City of Roanoke
Planning, Building, & Development
COMPREHENSIVE DEVELOPMENT PLAN
FIELD REVISION APPROVED
by Adrian Gilbert 12/26/2017

STEEL DYNAMICS
Spare Parts Warehouse 2017
Tax # 6021103
City of Roanoke, Virginia

SHEET TITLE: Utility Plan
Site Layout & Dimensional Plan

SHEET NO.
C03

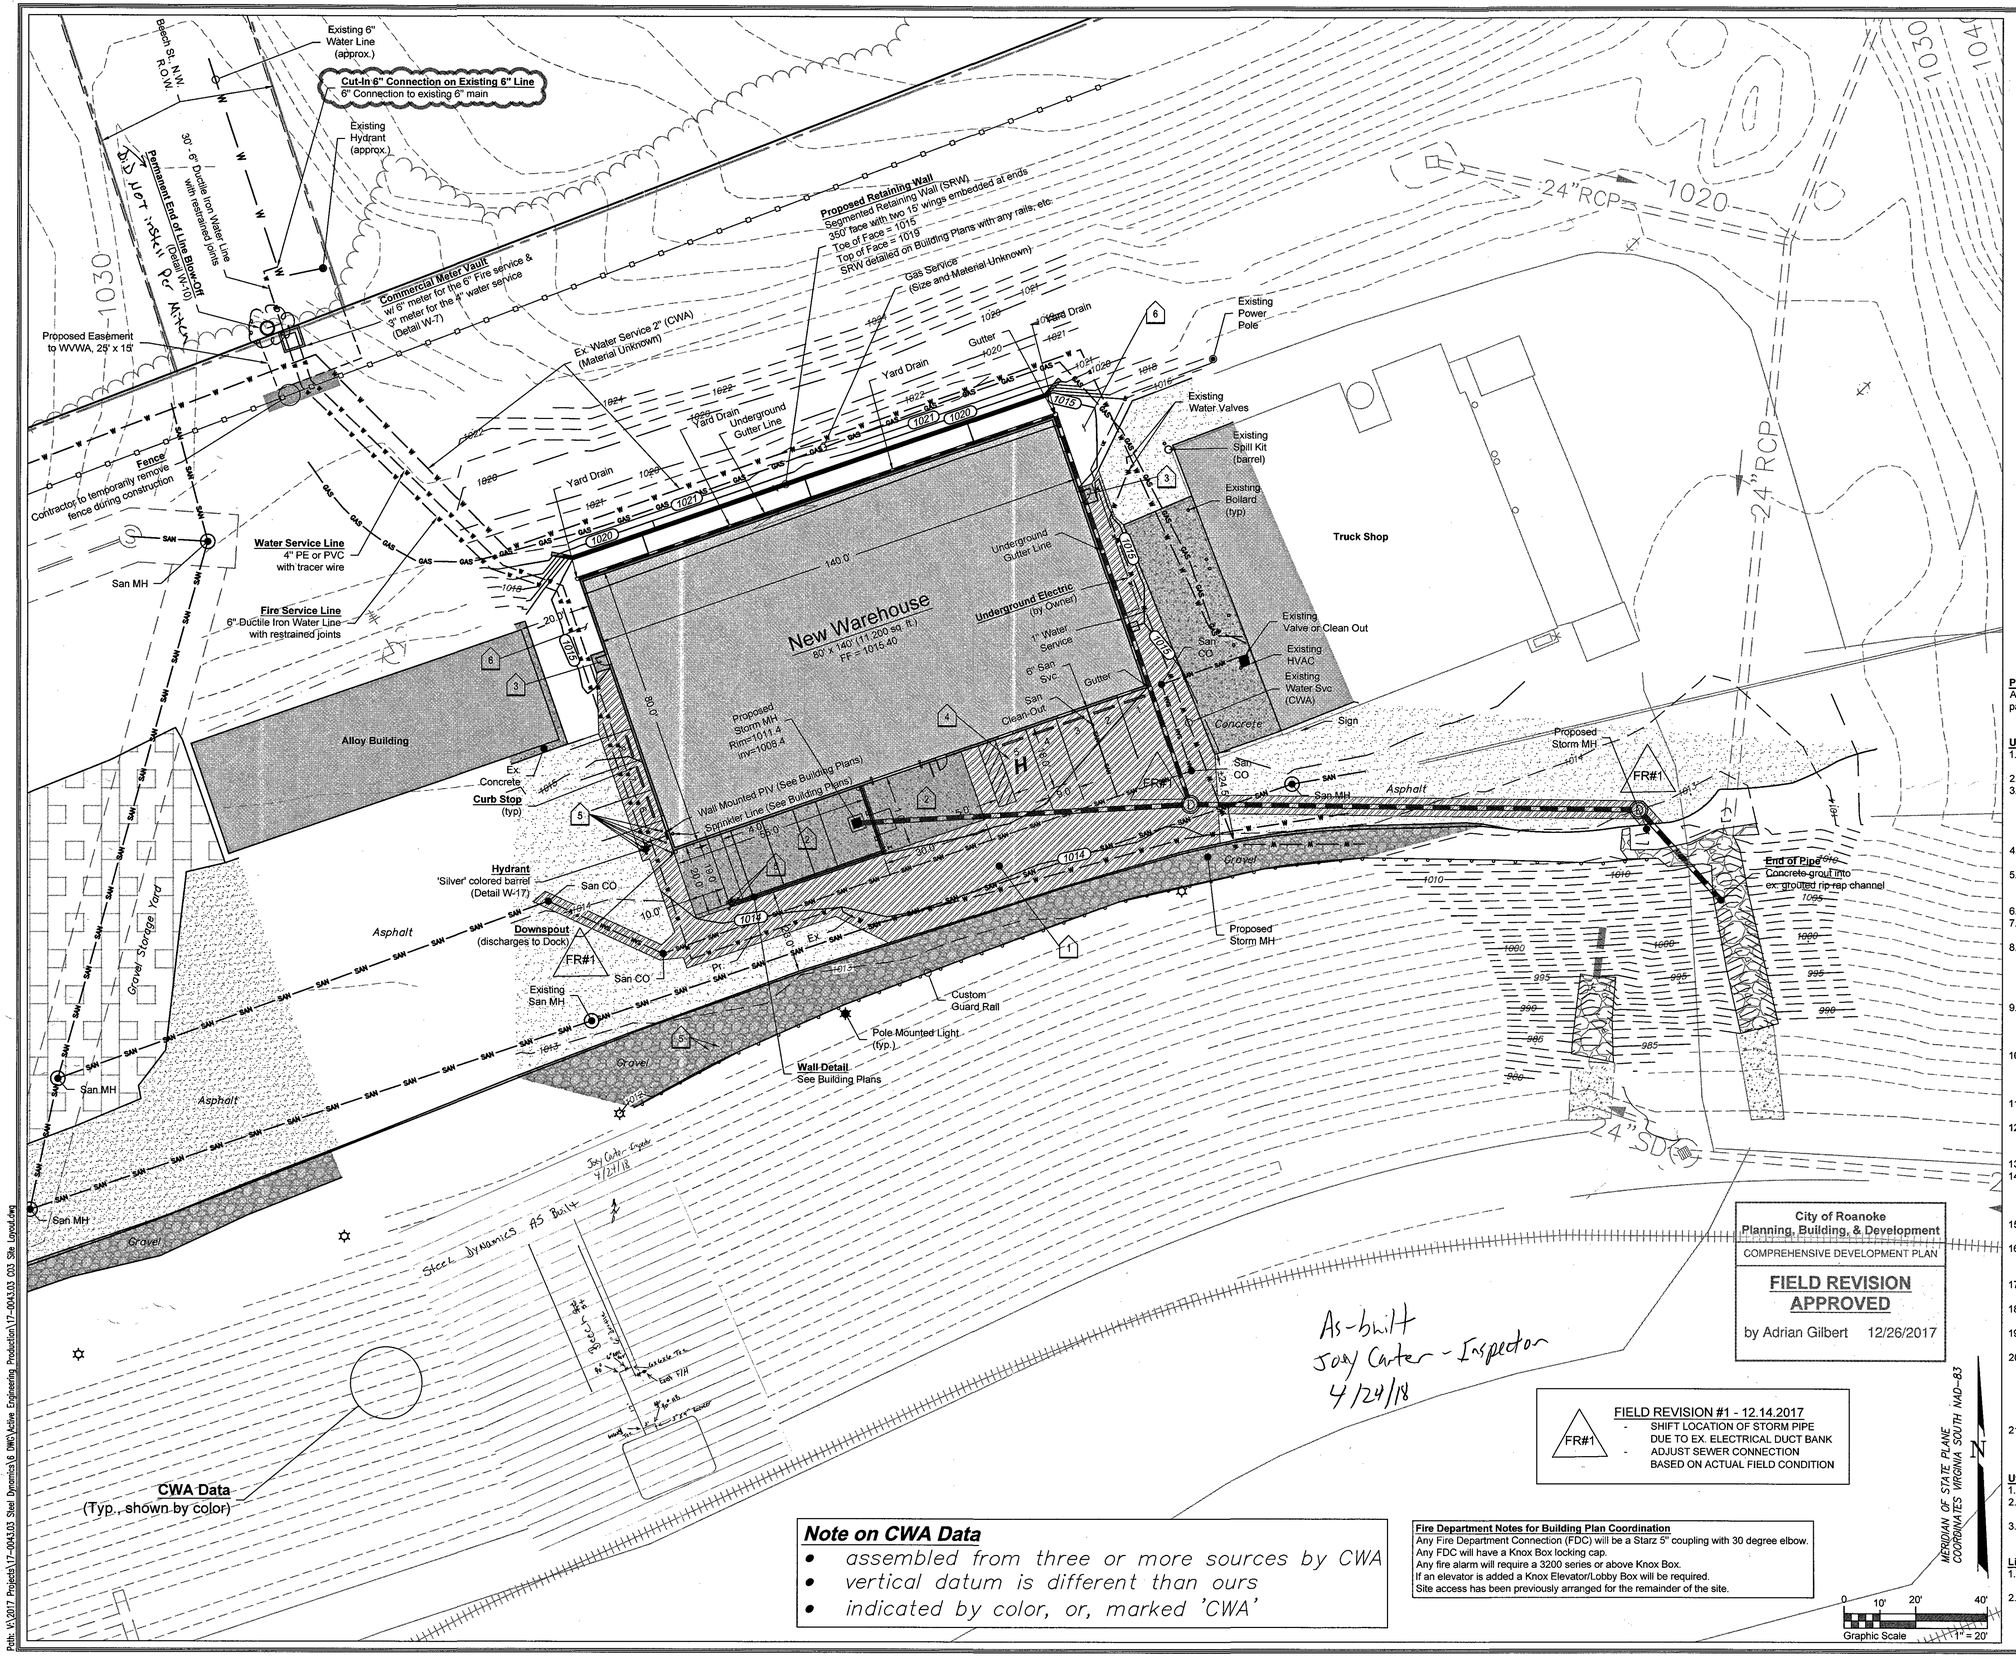
FR#1 — FIELD REVISION #1 - 12.14.2017
- SHIFT LOCATION OF STORM PIPE DUE TO EX. ELECTRICAL DUCT BANK
- ADJUST SEWER CONNECTION BASED ON ACTUAL FIELD CONDITION
